May 3, 2016

SUBJECT: PIER 4 PHASE 2 RECONFIGURATION
PROJECT NO. 091251
CONTRACT NO. 070136

ADDENDUM NUMBER THREE

**SECTION-CRANE STOP
BASE PLATE- BACK POST**

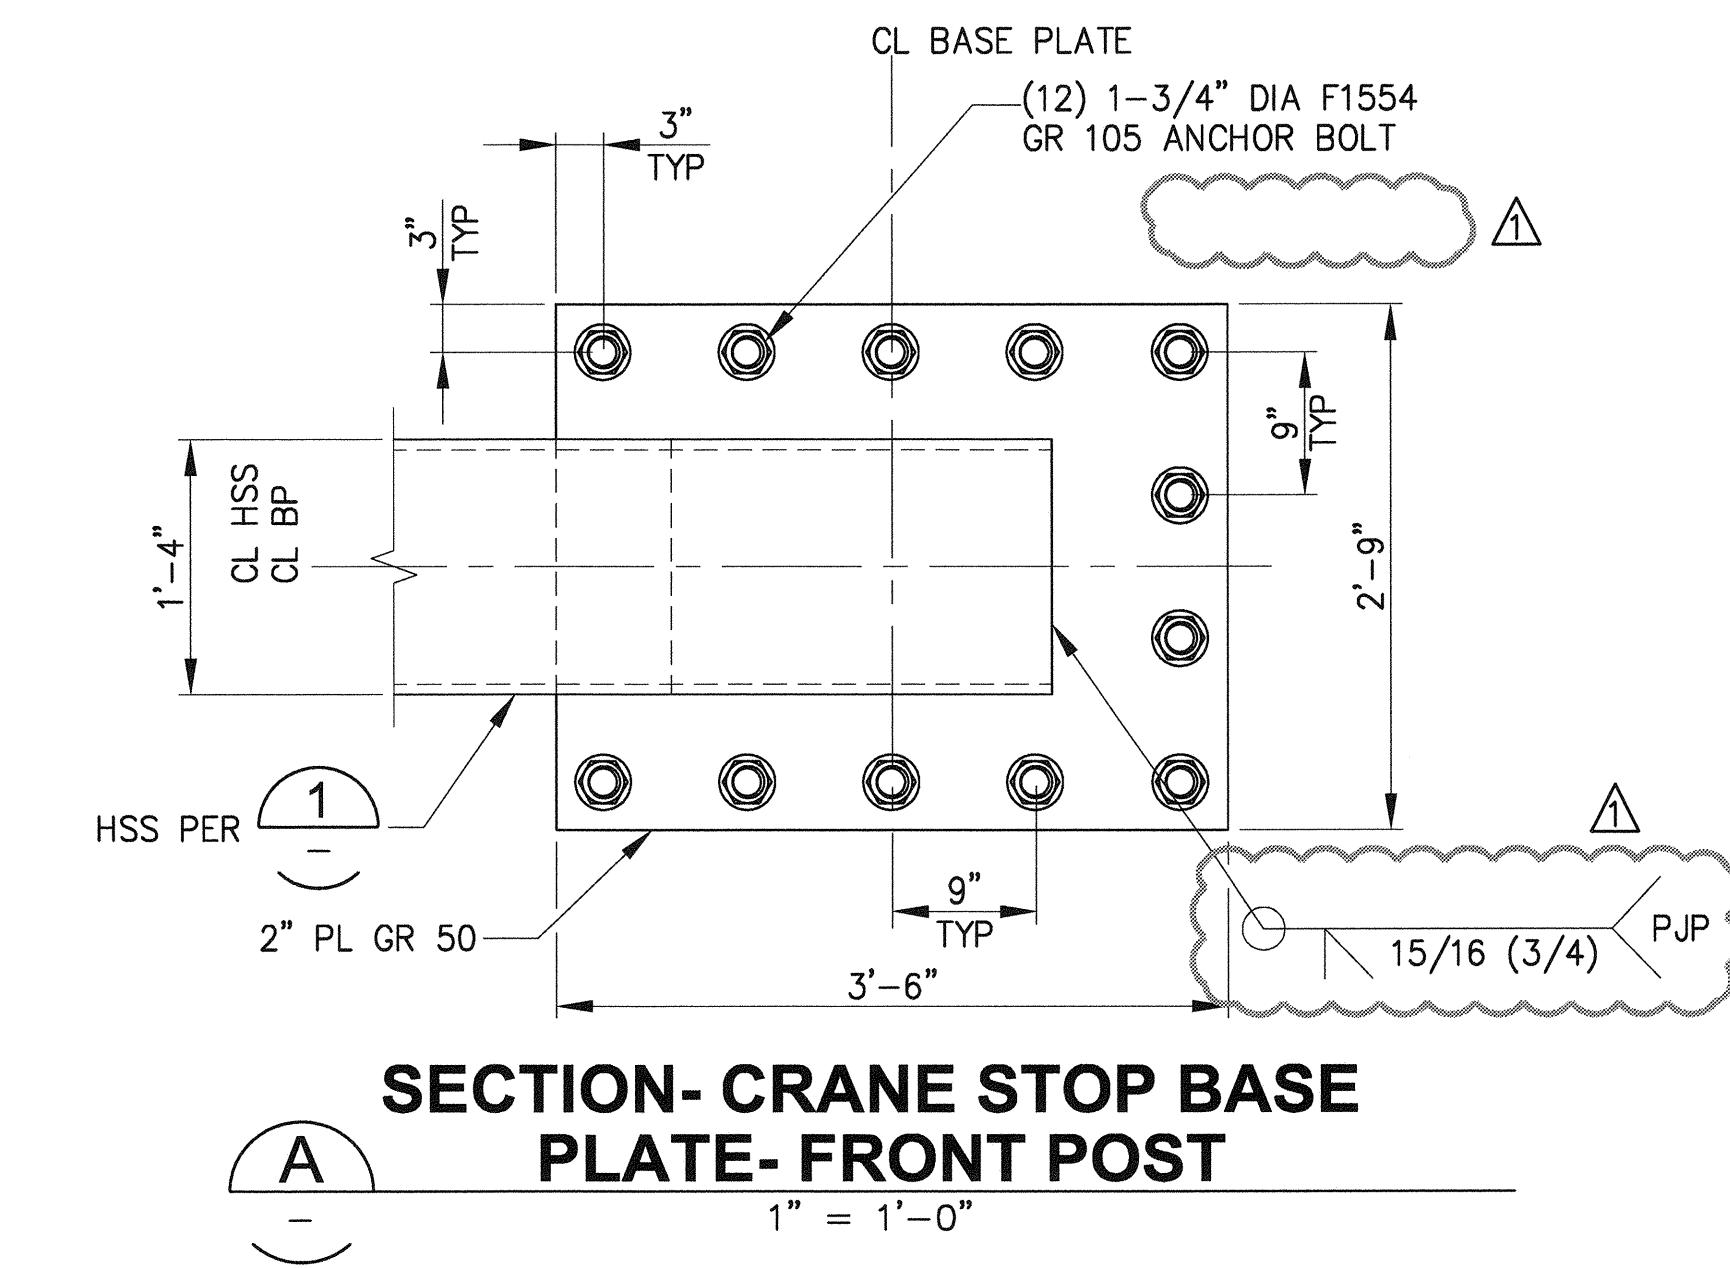
I. DRAWING S36.1 CRANE STOP DETAILS (SHEET 369)

1. **REVISE** height of crane stop, as denoted in Detail 1 Elevation –Crane Stops Landside and Waterside; anchoring, as denoted in Detail 3 Detail – Crane Stop Base Plate Anchoring – Front Post; and welds, as denoted in Detail A Section – Crane Stop Base Plate – Front Post. (See Attachment J to this Addendum No. 3)

TYPICAL DAYLIGHT HARVESTING 1 OR 2 RELAY ROOM CONTROLLER WIRING DETAIL - ENCLOSED OFFICE WITH DAYLIGHT

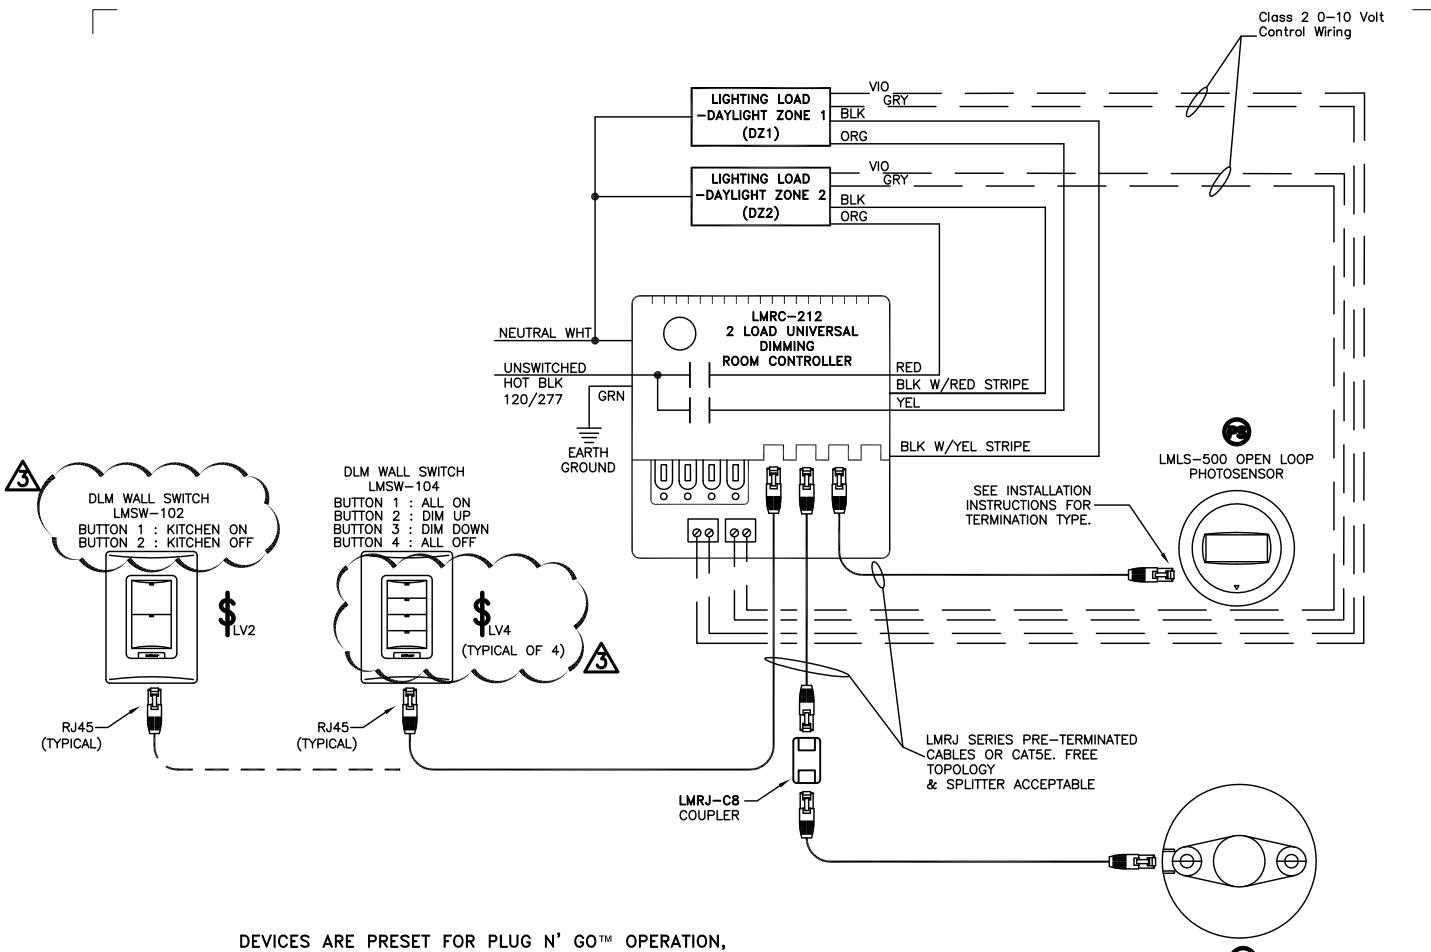
M. DRAWING E5.01 – MARINE BUILDING ELECTRICAL DETAILS (SHEET 494) – TYPICAL DAYLIGHT HARVESTING 1 OR 2 RELAY ROOM CONTROLLER WIRING DETAIL – ENCLOSED OFFICE WITH DAYLIGHT

1. **REVISE** low voltage switch LV2 to a two-button switch. Revise function to say KITCHEN ON AND KITCHEN OFF. (See Attachment K to this Addendum No. 3)
2. **REVISE** low voltage switch LV4 to a four-button switch. (See Attachment K to this Addendum No. 3)
